Product/Process Change Notice (PCN)																																									
<input type="checkbox"/> Major Change <input checked="" type="checkbox"/> Minor Change																																									
PCN Number: PCN_FrqSPXO_20250220 Affected Series: WE-SPXO Affected Part Number: See table below PCN Date: 2024-11-20 (YYYY-MM-DD) Effective Date: 2025-02-20 (YYYY-MM-DD)	Change Category: <input type="checkbox"/> Equipment/Location <input checked="" type="checkbox"/> General Data <input type="checkbox"/> Material <input type="checkbox"/> Process <input type="checkbox"/> Product Design <input type="checkbox"/> Shipping/Packaging <input type="checkbox"/> Supplier <input type="checkbox"/> Software																																								
Contact: Product Management Phone: +49 (0) 7942 - 945 5001 Fax: +49 (0) 7942 - 945 5179 E-Mail: pcn.eisos@we-online.com	Datasheet Change: <input checked="" type="checkbox"/> Yes <input type="checkbox"/> No Attachment: <input type="checkbox"/> Yes <input checked="" type="checkbox"/> No																																								
DESCRIPTION OF CHANGE: <p>Because of a database mismatch, Würth Elektronik eiSos will correct the RoHs status (1), packaging detai

3. Correction of the Product Dimensions:

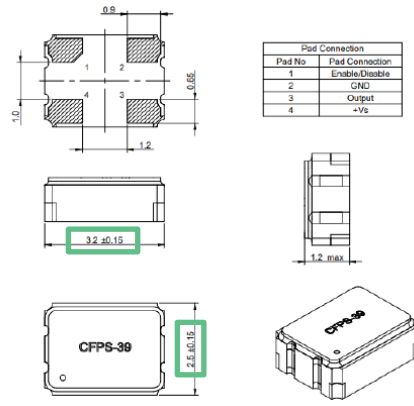
Before	After										
Product Dimensions	 <p>Pad Connections 1. Enable/Disable 2. GND 3. Output 4. +Vs</p>

Pad No.	Pad Connection	1	Enable/Disable	2	GND	3	Output	4	+Vs
Pad No.	Pad Connection											
1	Enable/Disable											
2	GND											
3	Output											
4	+Vs											
L	3.2 ± 0.1	3.2 ± 0.15										
W	2.5 ± 0.1	2.5 ± 0.15										
H	1.2 max	1.2 max
